DALFEN INDUSTRIAL

6106 ROSS RD

SP-2020-0407D

VARIANCE REQUESTS

VARIANCE REQUESTS 1&2

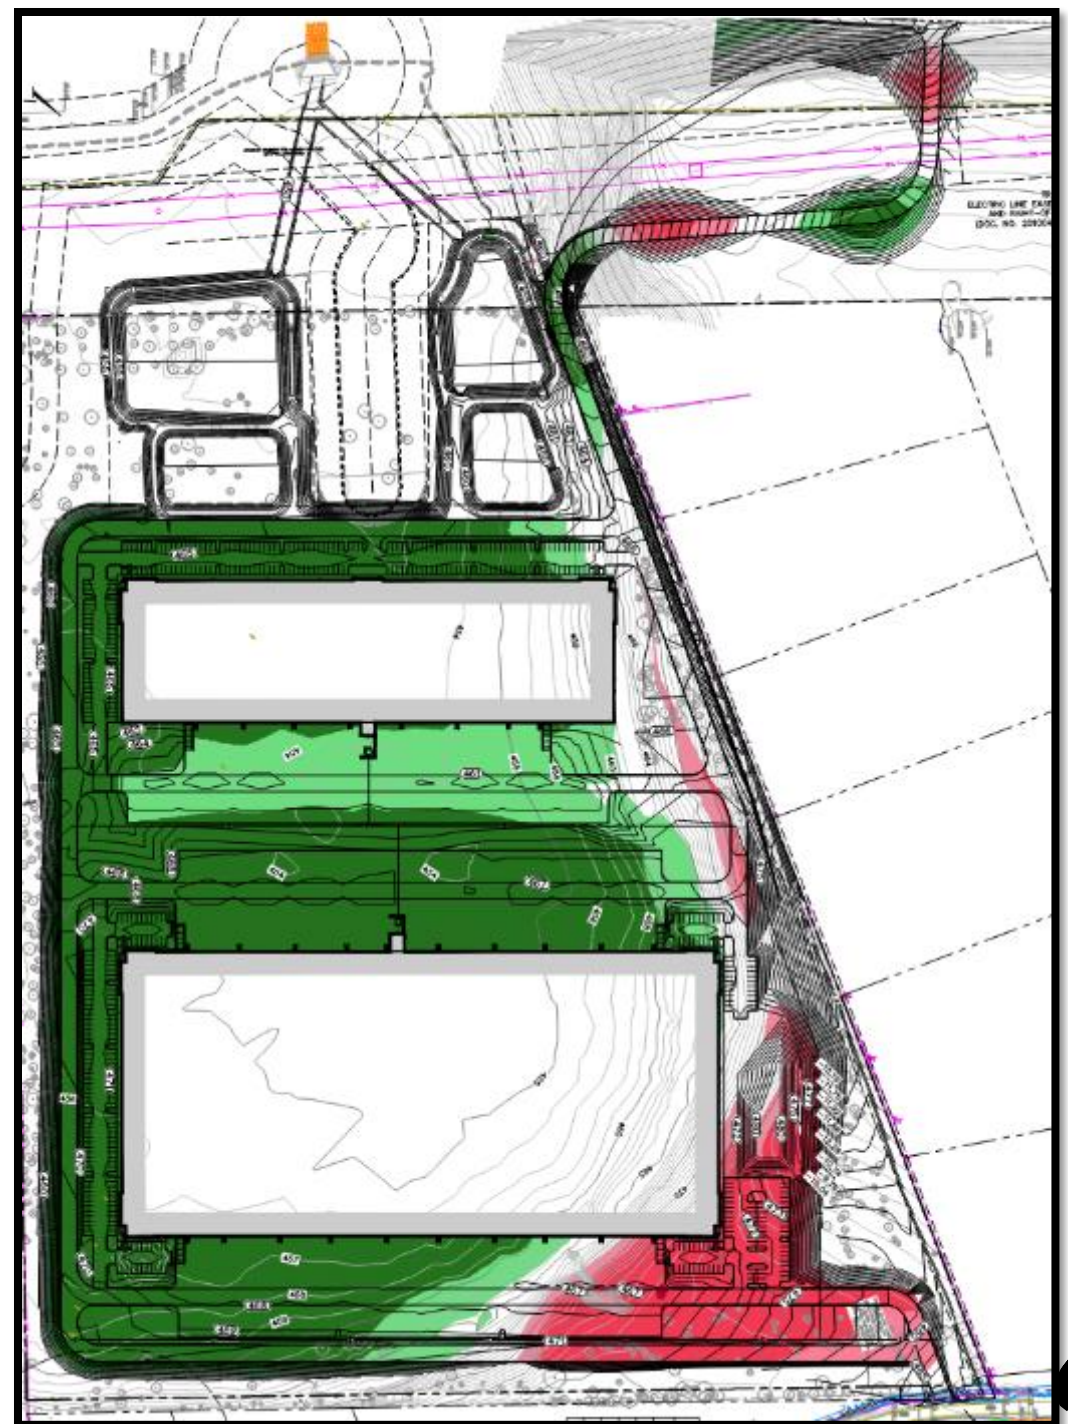
1. Cut to 17
2. Fill to 18

VARIANCE REQUESTS 1&2 BACKGROUND

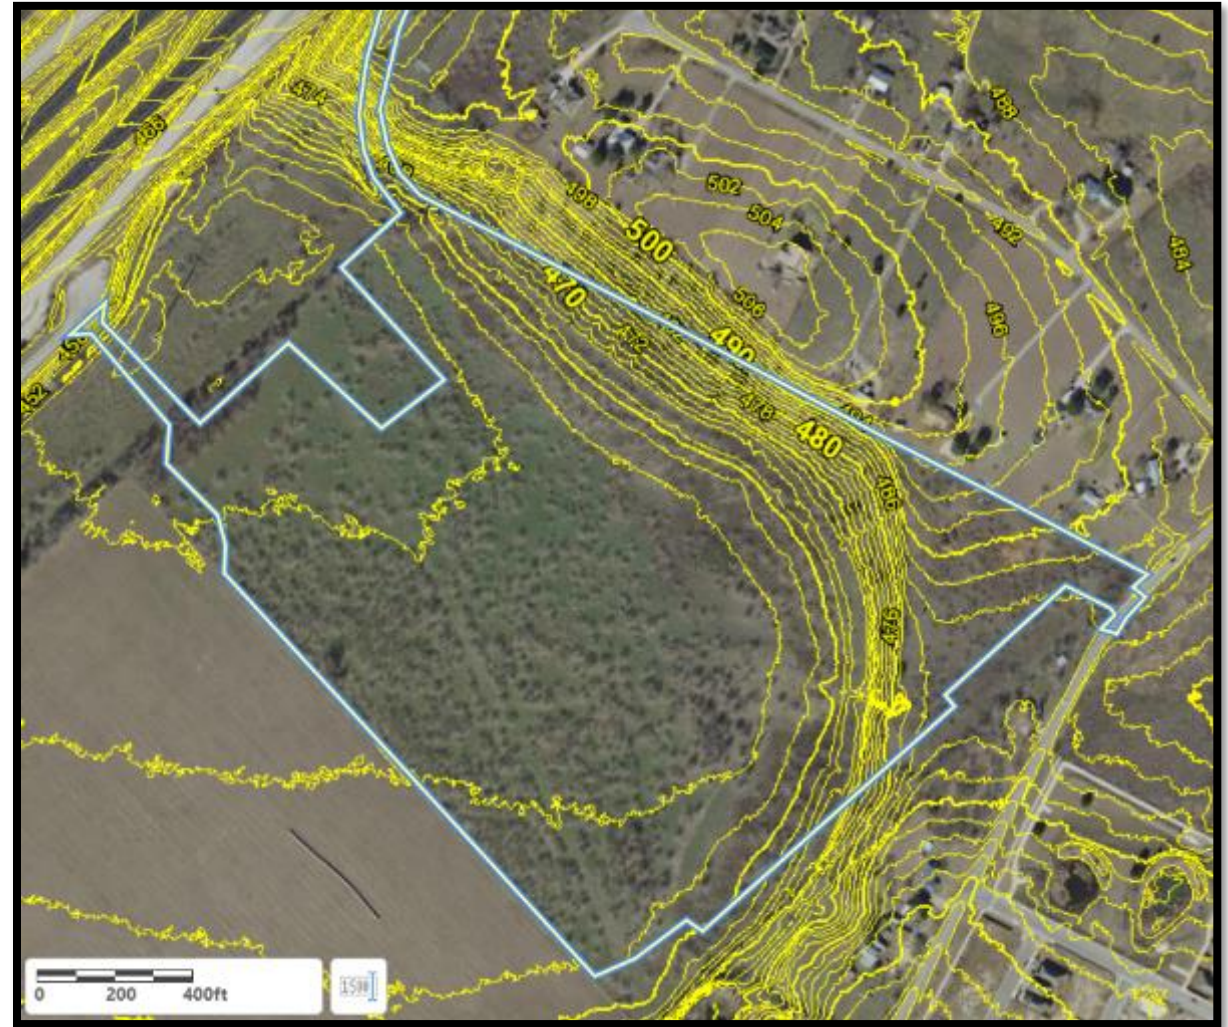
- Requirements for truck maneuverability and loading dock elevations.
- An existing headwall (five 5'x 6' box culverts conveying stormwater under Moore's Crossing Blvd.) to which the site must drain.

VARIANCE REQUEST 3

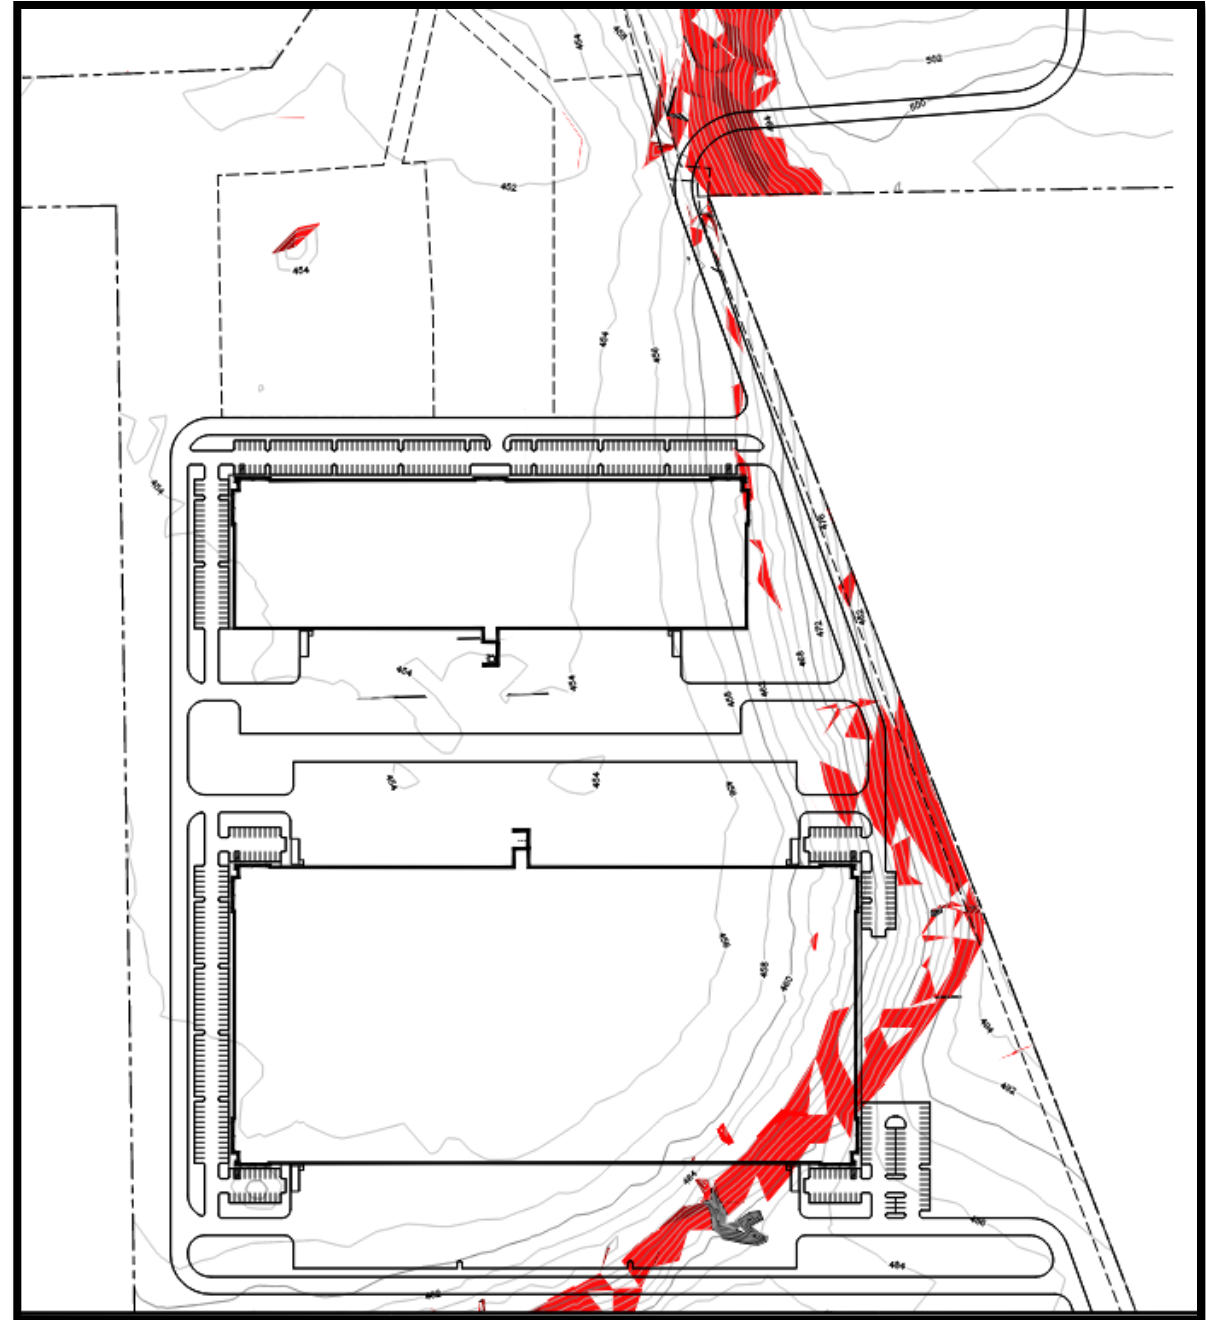
Construction of a driveway on a slope with a gradient exceeding 15 percent.

VARIANCE REQUEST 3

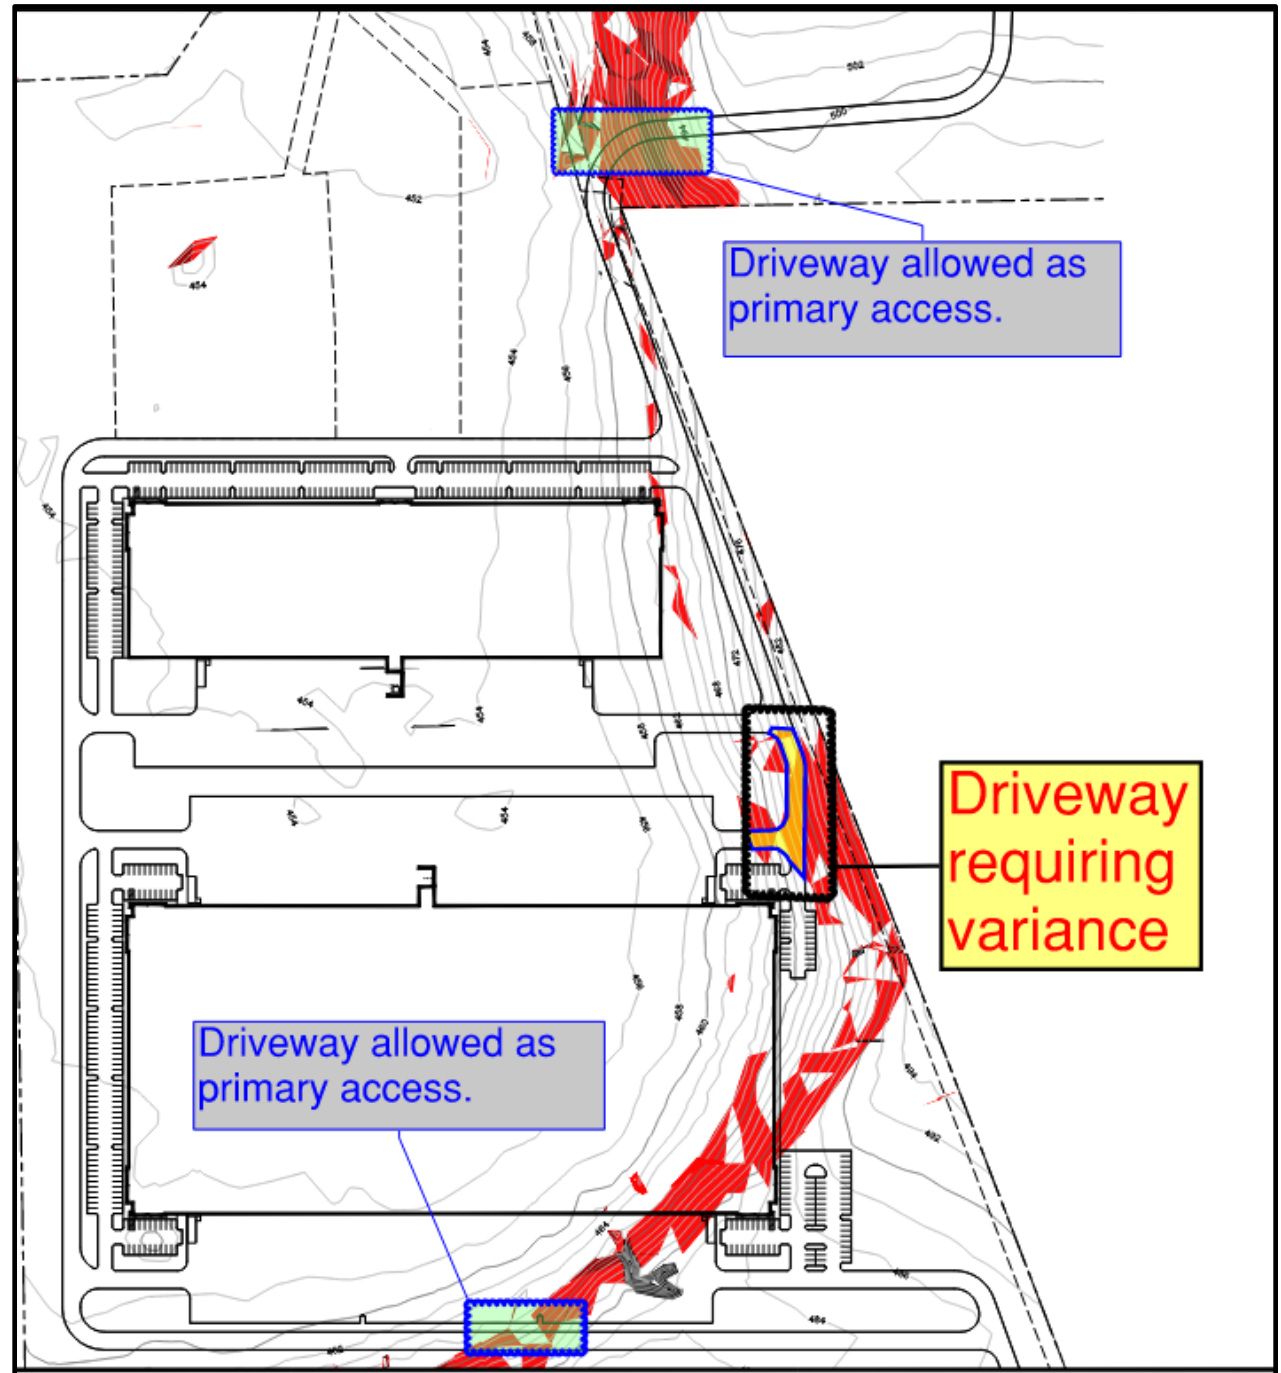
Construction of a driveway on a slope with a gradient exceeding 15 percent.

VARIANCE REQUEST 3 BACKGROUND

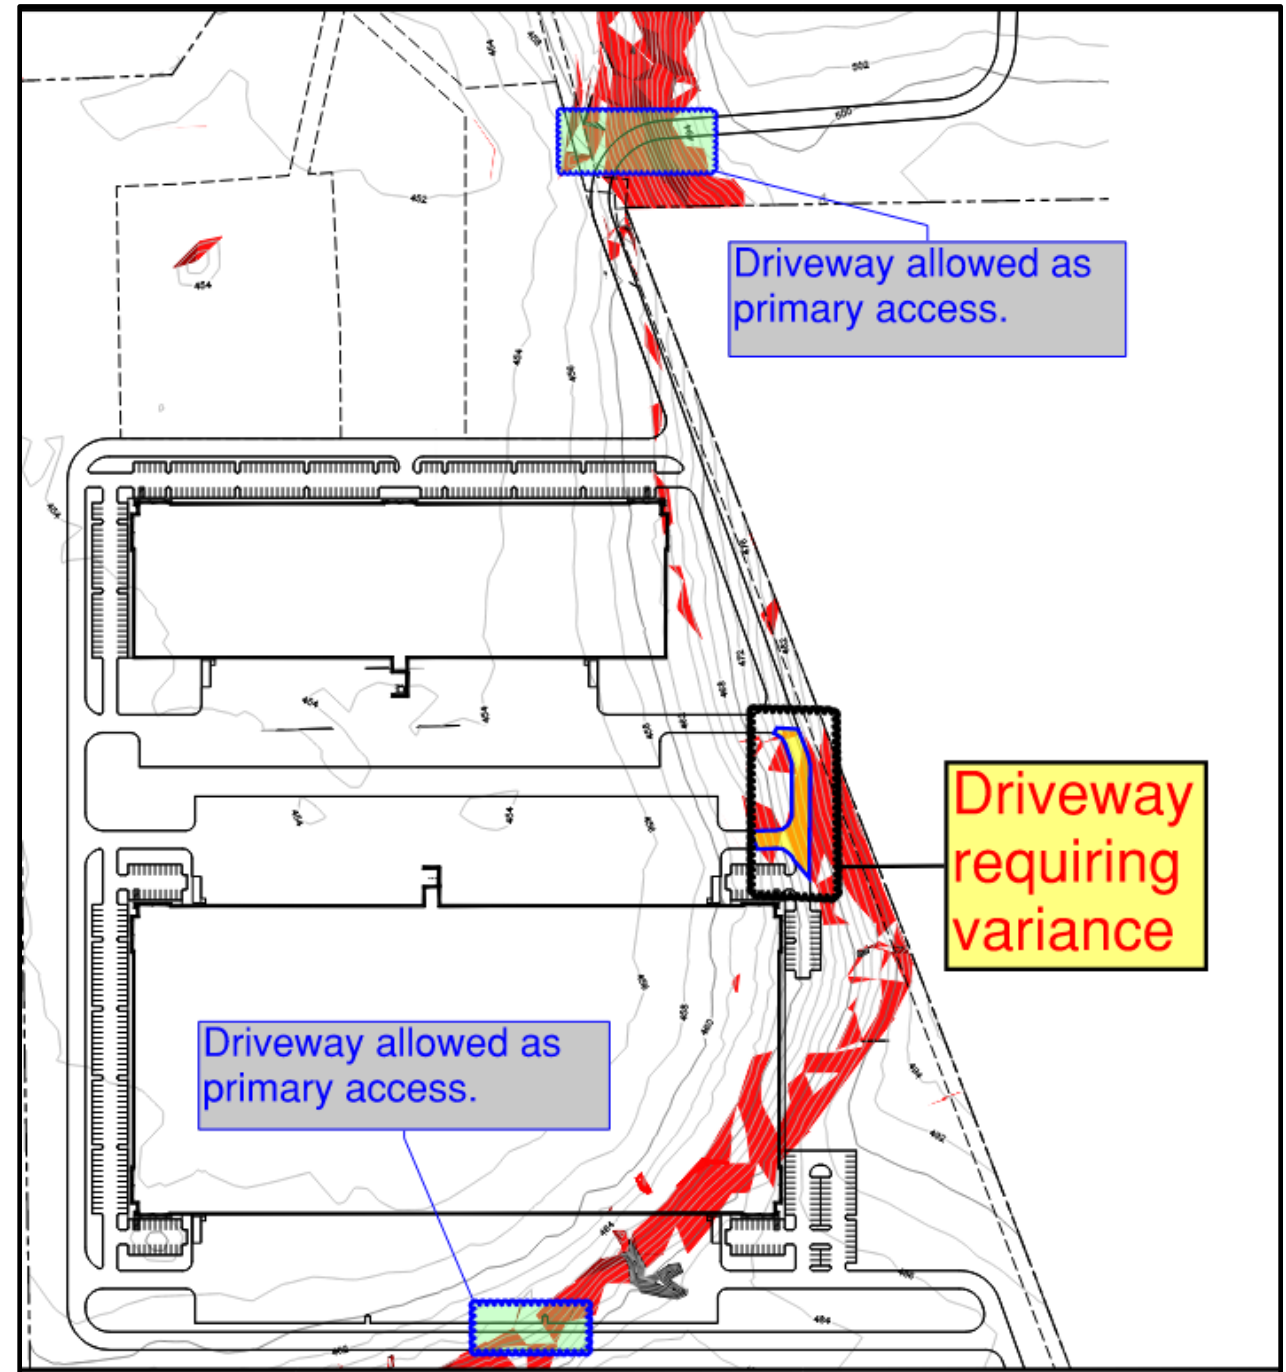
- Five (5) acres out of the 92-acre site have a grade over 15 percent.
